Technical Service Bulletin

10 Oil is lost from the filler cap

10 23 25 2059446/6 January 24, 2023. Supersedes Technical Service Bulletin Group 10 number 22-24 dated August 23, 2022, for reasons listed below.

Figure 1. Breather line for the Turbocharged V6.

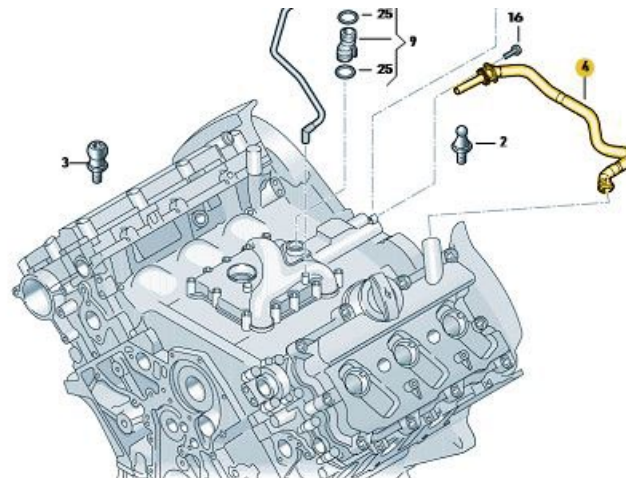
A faulty membrane in the breather line can result in excess pressure in the crankcase and therefore some oil is lost through the filler cap.

A breather line with an improved membrane has been implemented in production.

Replace the breather line (different variants available, only order by VIN) by following the Elsa repair manual (Figures 1 and 2).
